Access Compliance Report

Public Rights-of-Way

(Curb Ramps)

Intersection ID: 50600	Main Street: BENDING_BRANCH_RD	Cross Street: HEARTLEAF_RD	Location: S
ADA ID: E64ECF1EA545	Ramp Type: Perp	Initial Pass/Fail: Fail	Overall Compliance: No
Codes/Mitigation Info/Possible Solution			Severity Score: 35
			Field Measurements/Component Compliance

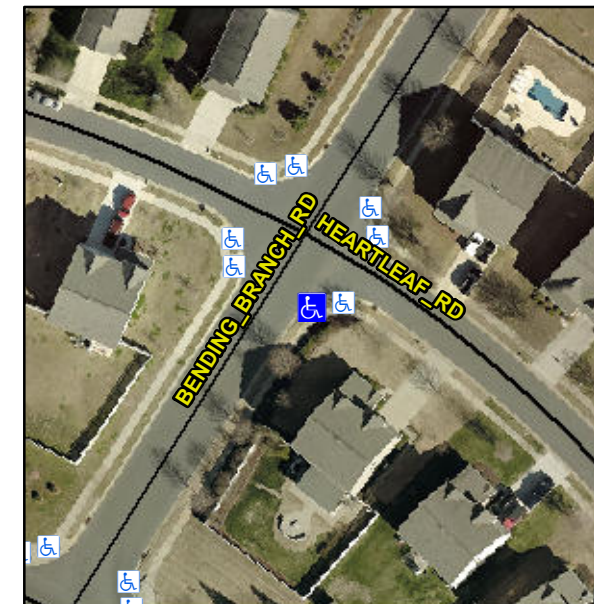
Not Found, R304.5.1, R304.2.2, R304.5.3

Compliance	Description	Data	Compliance	Description	Data
N/A	Ramp Length (in)	51.5	No	Ramp Slope (%)	13.0
No	Ramp Width (in)	47.0	No	Ramp XSlope (%)	4.0
N/A	Flare Type LT	N/A	N/A	Flare Type RT	N/A
N/A	Flare Slope LT (%)	N/A	N/A	Flare Slope RT (%)	N/A
N/A	Flare Traversable LT?	N/A	N/A	Flare Traversable RT?	N/A
N/A	Landing Length (in)	N/A	N/A	DWS Provided?	N/A
N/A	Landing Width (in)	N/A	N/A	DWS Contrast?	N/A
N/A	Landing Slope (%)	N/A	N/A	DWS Length (in)	N/A
N/A	Landing X Slope (%)	N/A	N/A	DWS Full Width?	N/A
N/A	Landing Curb? (Y/N)	N/A	N/A	DWS Offset (in)	N/A
N/A	Shared Landing?	N/A			
N/A	Gutter Ponding?	N/A	N/A	Gutter Slope (%)	N/A
N/A	Gutter Lip Ht (in)	N/A	N/A	Gutter X Slope (%)	N/A
N/A	Painted X Walk1?	No	N/A	Painted X Walk2?	N/A
	X Walk 1 Direction	To NW		X Walk 2 Direction	N/A
N/A	X Walk 1 Width (in)	N/A	N/A	X Walk 2 Width (in)	N/A
	X Walk 1 Slope (%)	1.9		X Walk 2 Slope (%)	N/A
	X Walk 1 X Slope (%)	3.7		X Walk 2 X Slope (%)	N/A

Remove & Replace Entire Ramp.
